GW - 028

**GENERAL
CORRESPONDENCE**

From: Chavez, Carl J, EMNRD
Sent: Wednesday, December 4, 2019 2:08 PM
To: 'Holder, Mike'
Cc: Denton, Scott; Combs, Robert; Leik, Jason; Griswold, Jim, EMNRD; Wade, Gabriel, EMNRD; Brancard, Bill, EMNRD; Ames, Eric, EMNRD
Subject: Artesia Refinery (GW-28) Request for Variance Under 19.15.29 et seq. NMAC
Attachments: 2019-11-27 HFNR Variance Request.pdf

The New Mexico Oil Conservation Division (OCD) is in receipt of the attached “Request for Variance” letter (letter) under 19.15.29 et seq. NMAC (Releases) dated November 27, 2019 for the above subject WQCC permitted facility (facility) under 20.6.2 et seq. NMAC (Ground and Surface Water Protection).

Secondary Reverse Osmosis Process Drawing

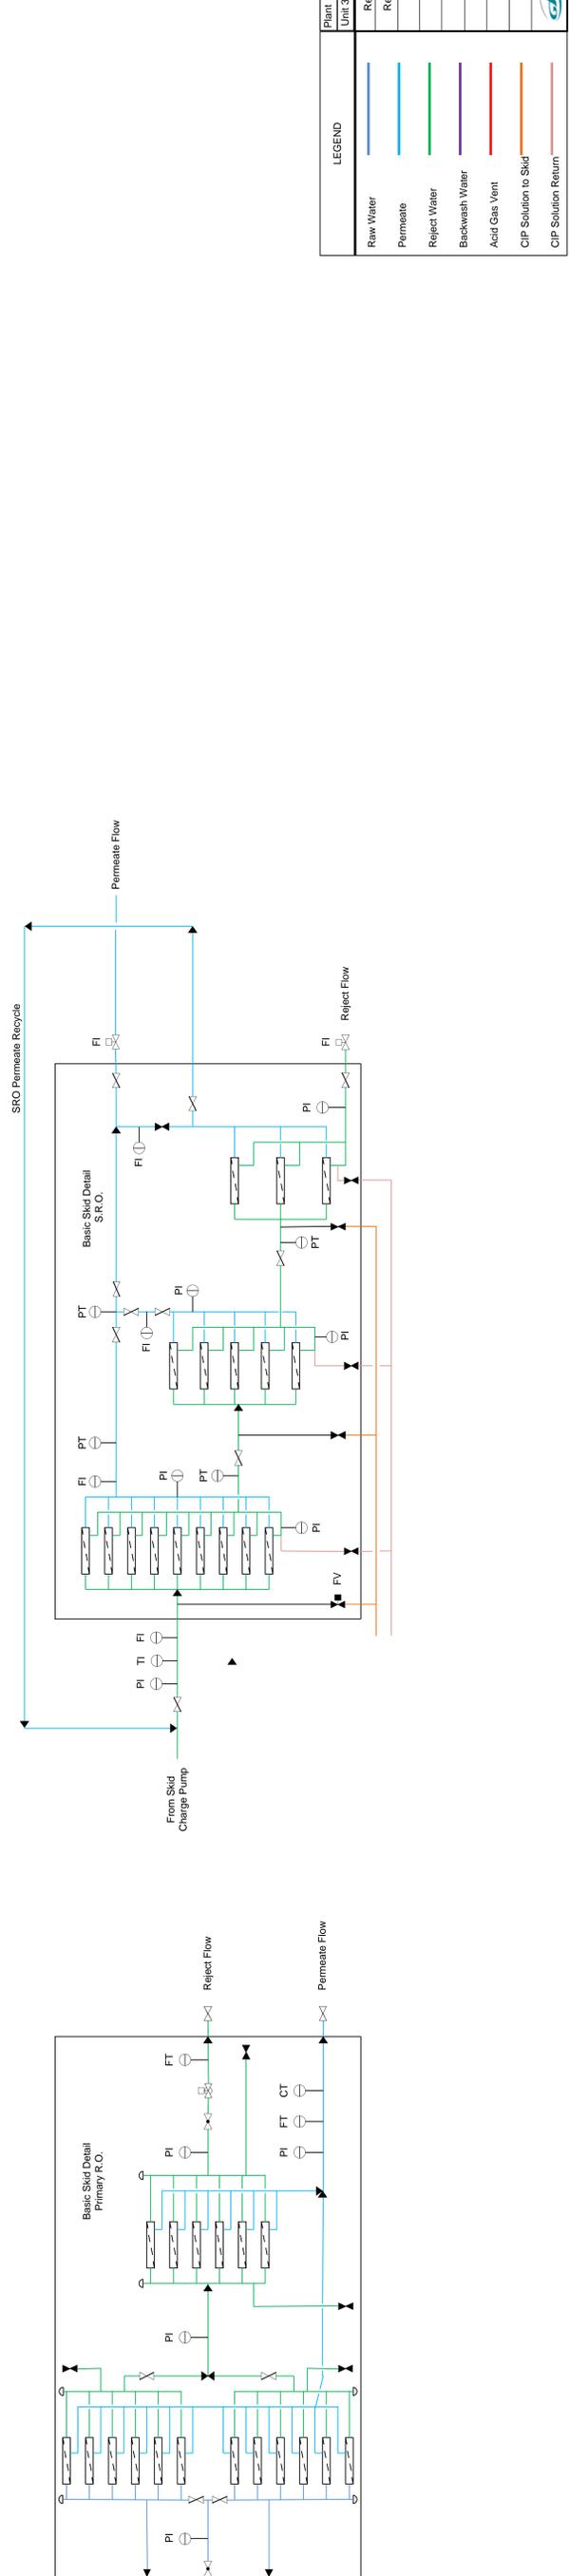
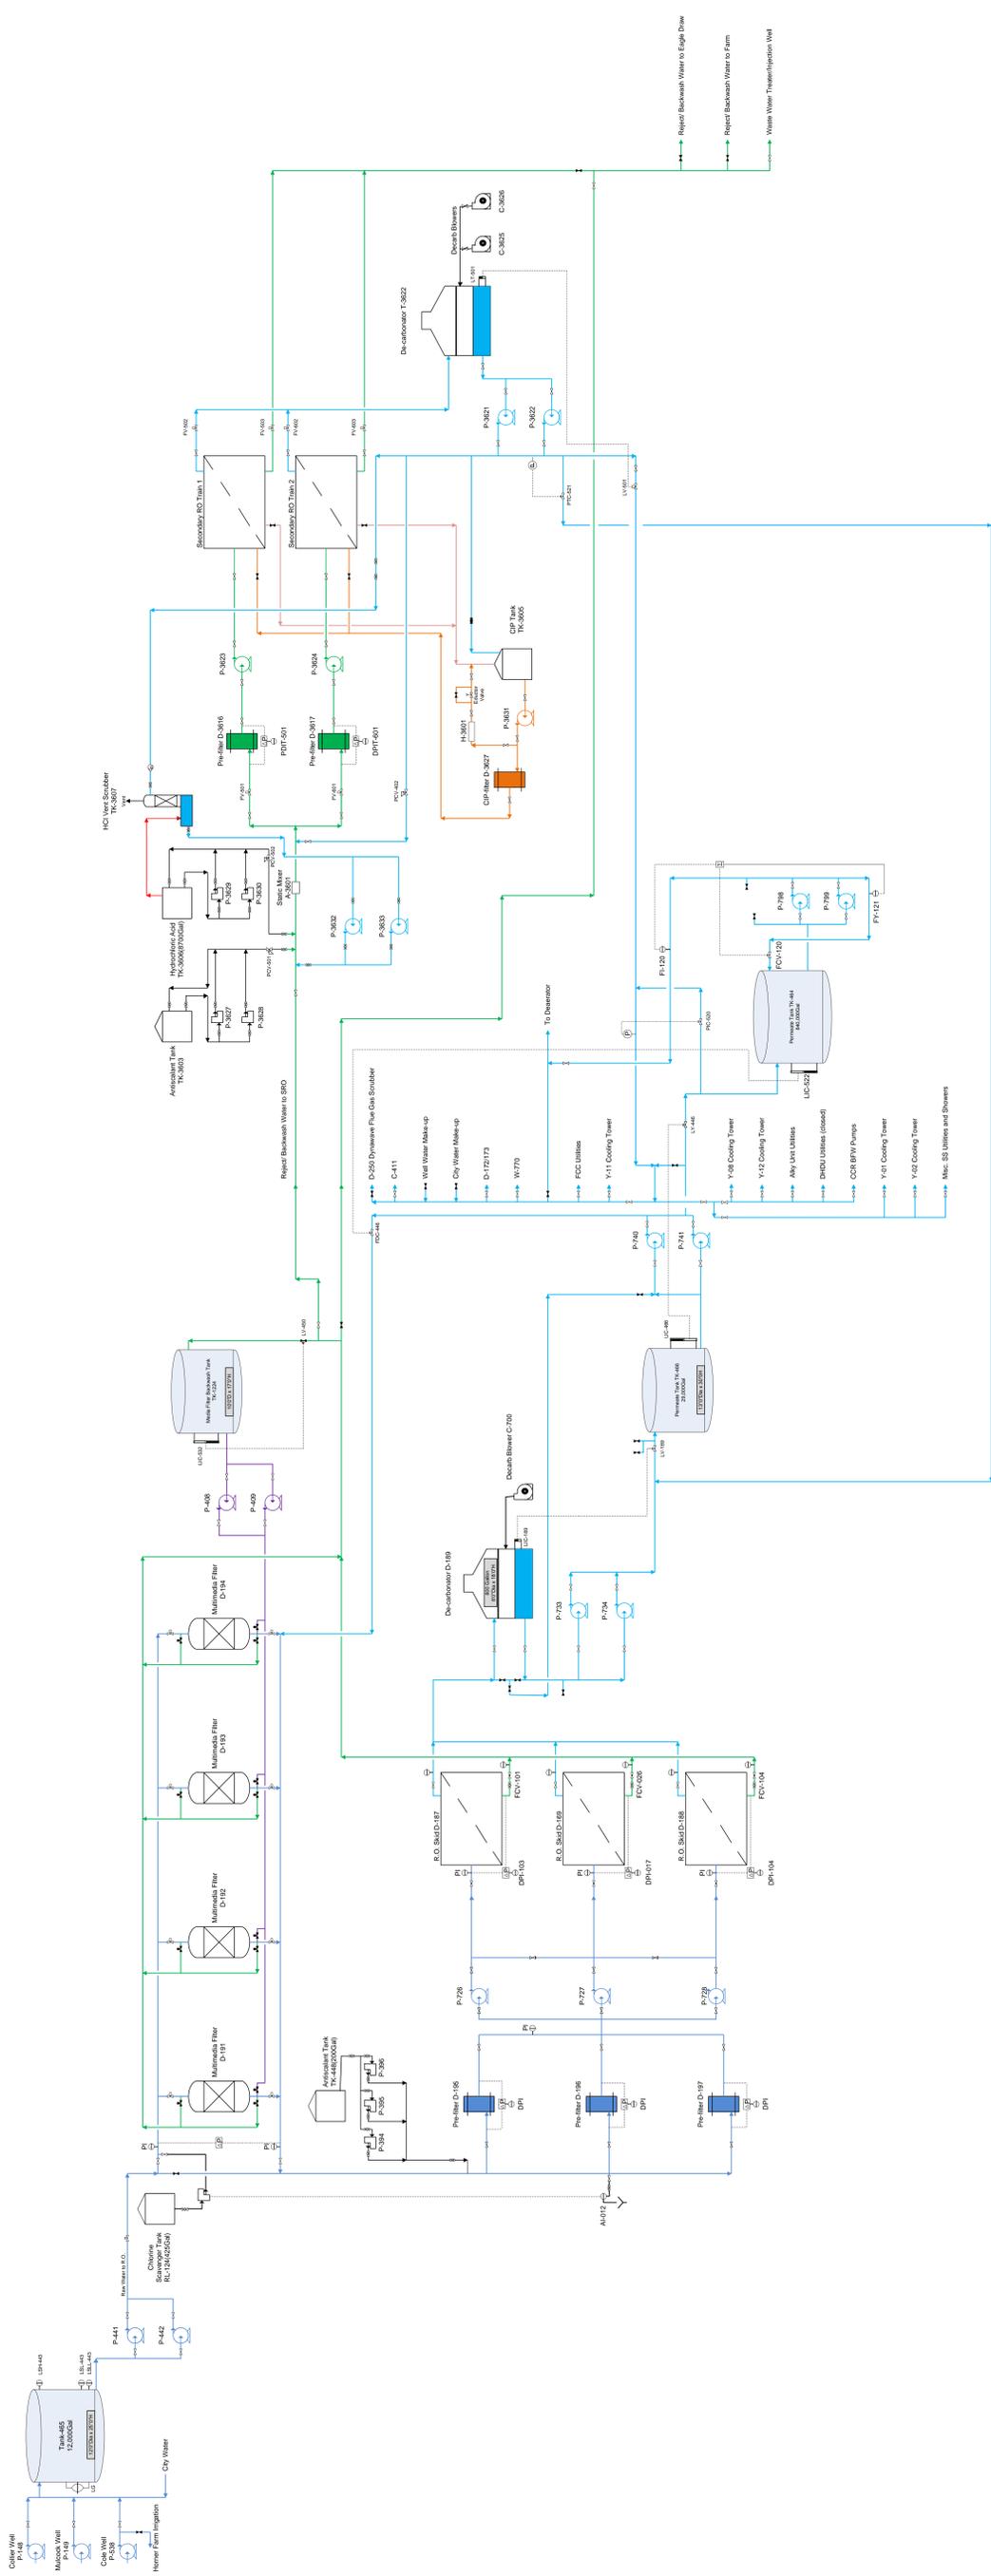
Carl,
Thanks for pointing out the error in the Attachment C to the submitted document. That was an oversight on my part and is not accurate of the SRO effluent. If you would, please accept this corrected figure to replace the submitted figure. If you have any questions or would like to discuss, please let us know.
Thanks,
Robert

Attachment "C" was amended to remove all references to land surface discharges.

I will amend the admin. record to replace Attachment C.

Attachment 1
South RO Reject Field Discharge Location

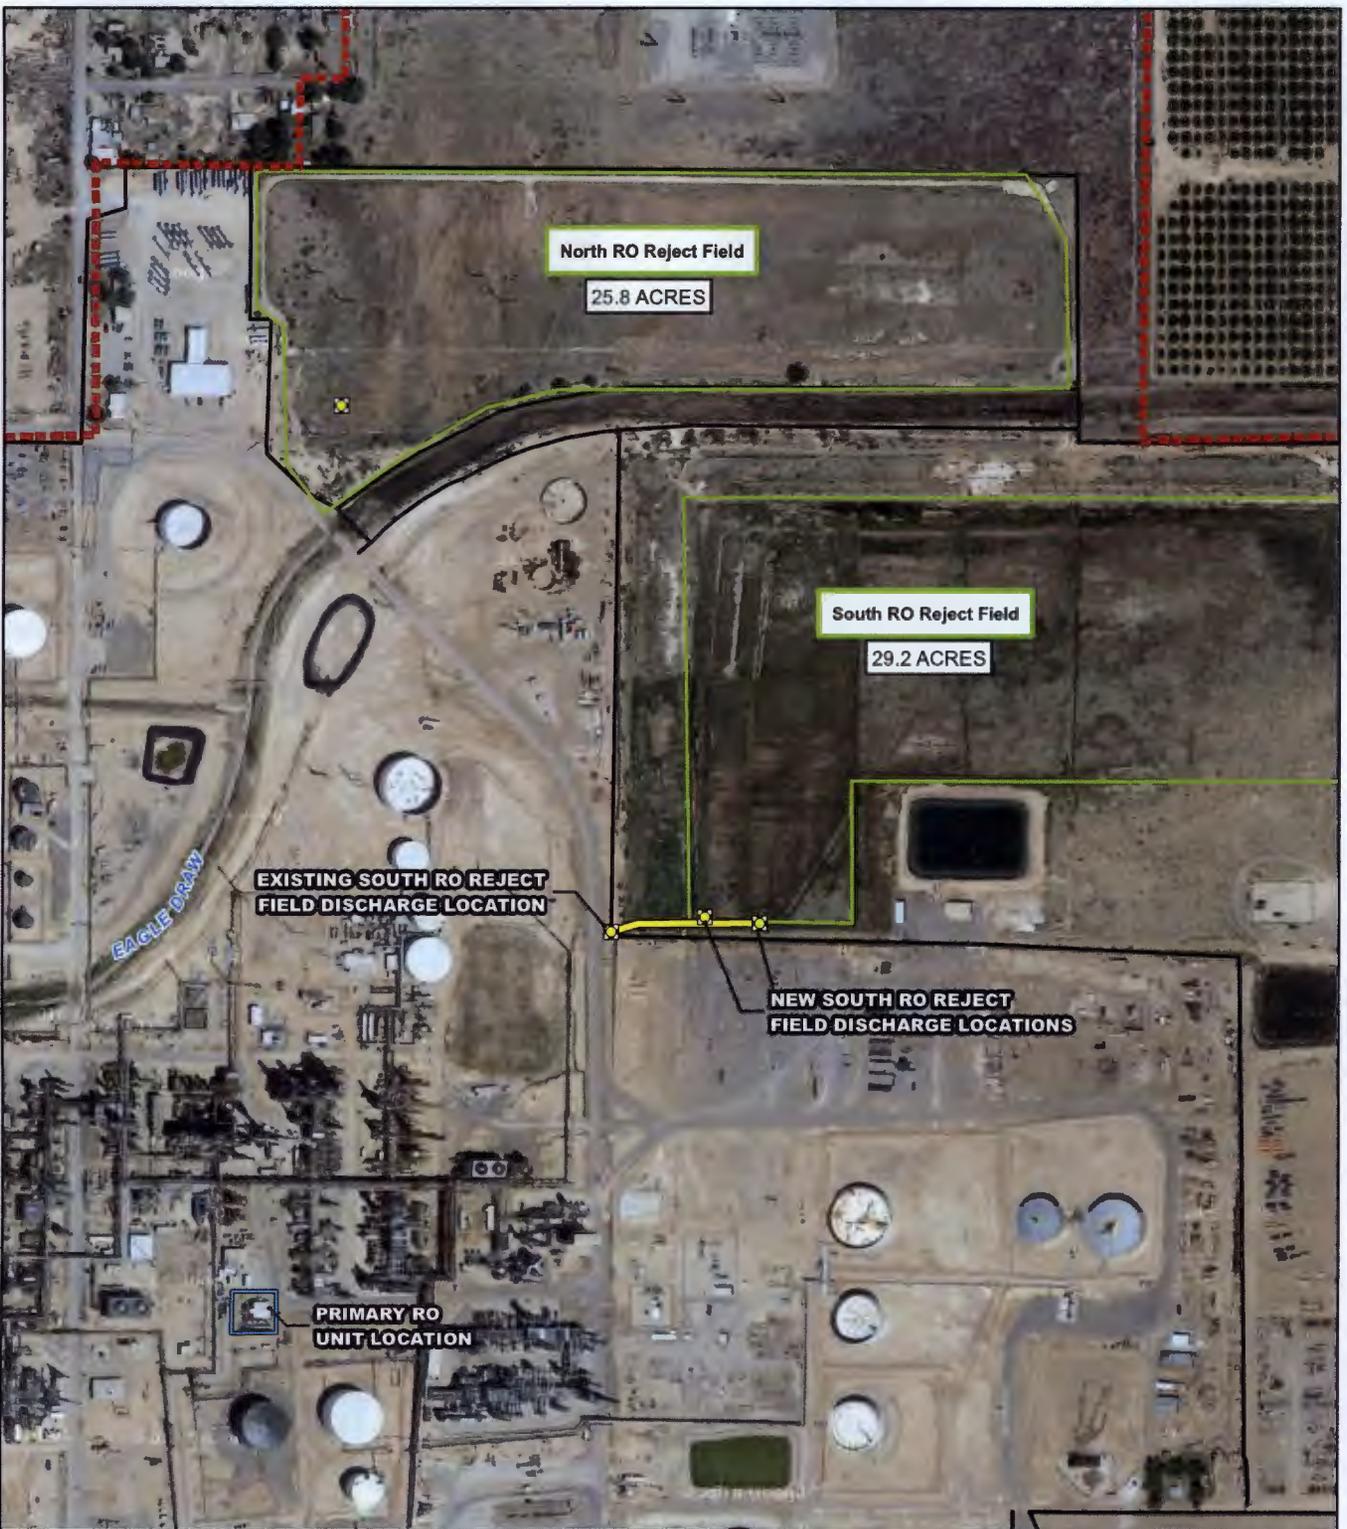
The Refinery plans to initiate a phytoremediation pilot study at the South RO Reject Field and, as a result, proposes to modify the discharge location at the South RO Reject Field. The new discharge locations are shown on the figures provided in Attachments 1 and 2. The relocated discharge locations are strategically placed to allow for diverting and metering the RO fluids into the phytoremediation test plot, as well as directing the remainder of the RO fluid discharge volume onto the South RO Reject Field beyond the extents of the phytoremediation test plot. The existing South RO Reject Field discharge location will be taken out of service for the duration of the pilot study.

A Notification of Change to Discharge Location (HF 7/21/17 Document) *(approved by OCD)*

- 1) Phytoremediation Pilot Project (call it "feasibility project" instead) within South RO Reject Field (OCD location approval of 7/28) *(Ok)*
 - a. Phytoremediation Work Plan needed *(Scott Denton will address)*
 - b. Abatement Plan (AP) submittal (Pre-closure) *(AP in this instance is for stopping discharge in RO Reject Farm Fields. No DP modification required for phytoremediation project- JG.)*
 - c. Navajo's reference to past reports, i.e., RO Reject Field Reports, Background GW Report, etc. *(Permittee only mentioning for AP required within 60 days from cessation of discharge into RO farm fields per A2a.)*
 - i. To be included in AP submittal? *(May or likely be considered in A1c and A2c)*
 - ii. OCD will consider, but may require other COAs as needed to complete AP *(Same as A1c above)*
